Common Structural Rules for Bulk Carriers and Oil Tankers

Corrigenda 1 to 01 January 2015 version

CORRIGENDA 1

This document contains editorial amendments or clarifications within the following Parts and Chapters of the Common Structural Rules for Bulk Carriers and Oil Tankers, 01 January 2015. The amendments are effective on 1st July 2015.

Figure 1 : Example of reinforcement at knuckles

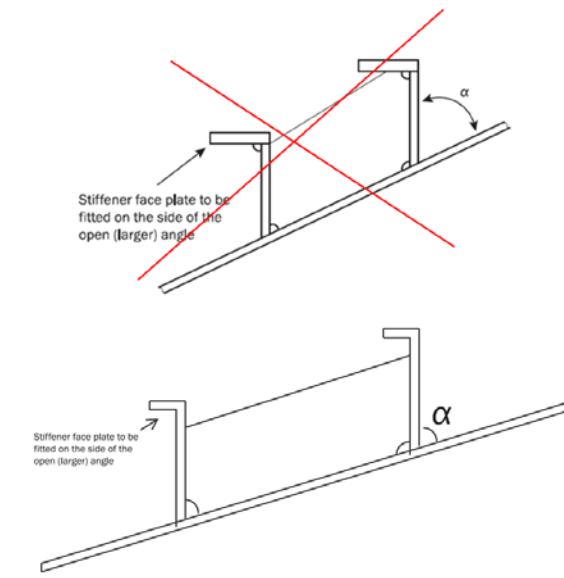
- b) Whenever a knuckle in a main member (shell, longitudinal bulkhead etc) is arranged, stiffening in the form of webs, brackets or profiles is to be connected to the members to which they are to transfer the load (in shear). See example of reinforcement at upper hopper knuckle in Figure 1.

h_{w1} , h_{w2} , h_{w3} , h_{w4} : Dimensions as shown in Figure 16.

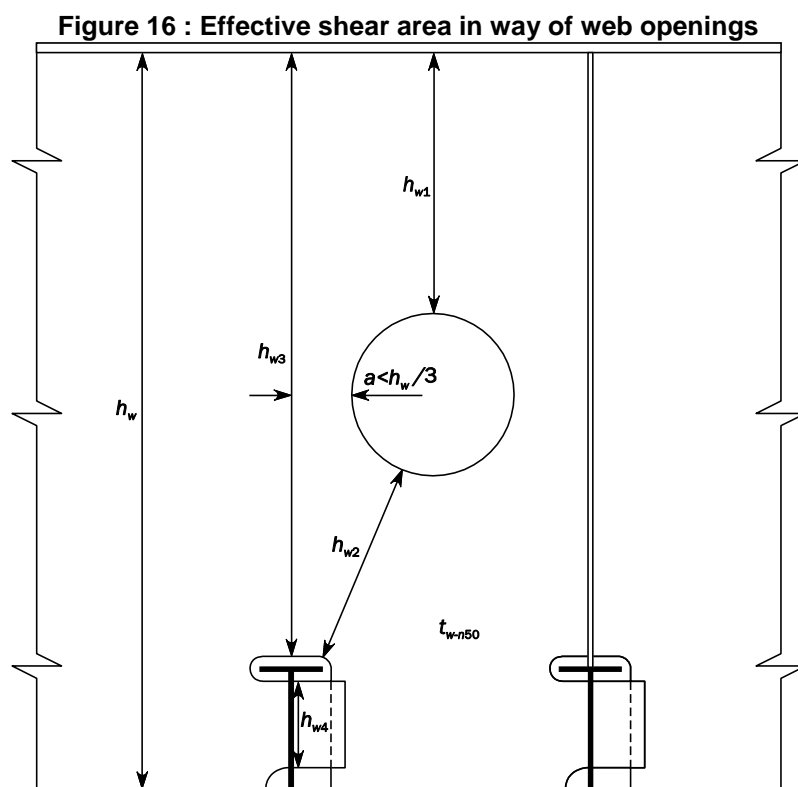
$$h_{eff} = h_{w3} + h_{w4}$$

$$h_{eff} = h_{w1} + h_{w2} + h_{w4}$$

**Table 3 : Buckling factor and reduction factor for plane plate panels**

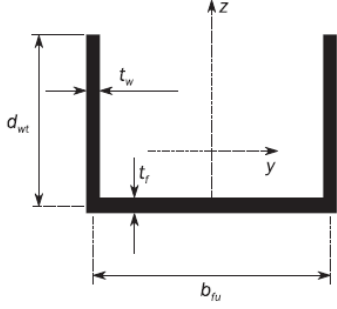
18 	-		<del>$K_\tau = 3^{0.5}(0.6 + 4/\alpha^2)$</del> <u>$K_\tau = \sqrt{3}(0.6 + 4/\alpha^2)$</u>	$C_\tau = 1$ for $\lambda \leq 0.84$
19 	-		$K_\tau = 8$	$C_\tau = \frac{0.84}{\lambda}$ for $\lambda > 0.84$
